**SUBMITTAL TO THE BOARD OF SUPERVISORS
COUNTY OF RIVERSIDE, STATE OF CALIFORNIA**

SUBJECT: TRANSPORTATION AND LAND MANAGEMENT AGENCY/TRANSPORTATION
DEPARTMENT: Approve Addenda to the Plans and Specifications, Accept the Low Bid and Award the Contract for the Construction of North Indian Canyon Drive Widening Project, Phase 2, in the Community of North Palm Springs, District 5. [\$1,998,488 Total Cost, \$5,500 Ongoing Cost - Local Funds 100%] (Companion Item to MT Item 14812 and 14889)

WIDENING PROJECT PHASE 2
18TH AVE TO DILLON RD

WO No. C6-0089

PREPARED BY PREPARED UNDER THE SUPERVISION OF: PROJECT ENGINEER DATE: 2/10/2021 PROJECT MANAGER DATE: 2/10/2021	TYPICAL CROSS SECTIONS	SHEET NO. X-1r
	N INDIAN CANYON DR WIDENING PROJECT 211+26 TO 244+50	SHEET 2 OF 15

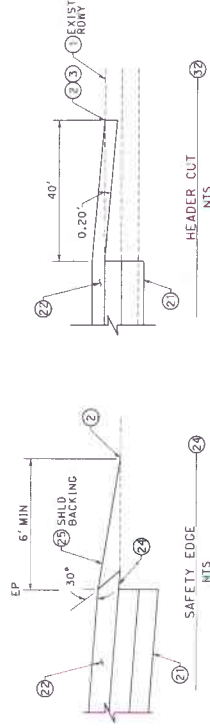
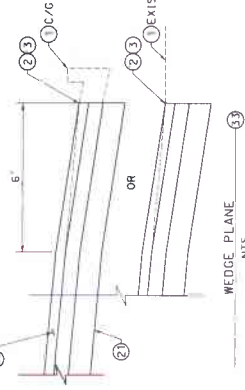
CHANGED SANDIT LINE TO MATCH PROPOSED SEWER LAYOUT. AFTER SEWER PROJECT, LINE MAY BE MODIFIED. THIS PROJECT IS NOT TO BE USED FOR ANY OTHER WORKING TO BE DONE FROM SEWER PROJECT SARCUT LINE WESTERLY.

⚠ CHANGED SAWCUT LINE TO MATCH PROPOSED SEWER INSTALLATION REMOVAL LIMITS. "EXIST EP SAWCUT AFTER SEWER PROJECT" LINE MAY BE MODIFIED DURING SEWER PROJECT CONSTRUCTION. WIDENING TO BEGIN FROM SEWER PROJECT SAWCUT LINE WESTERLY.
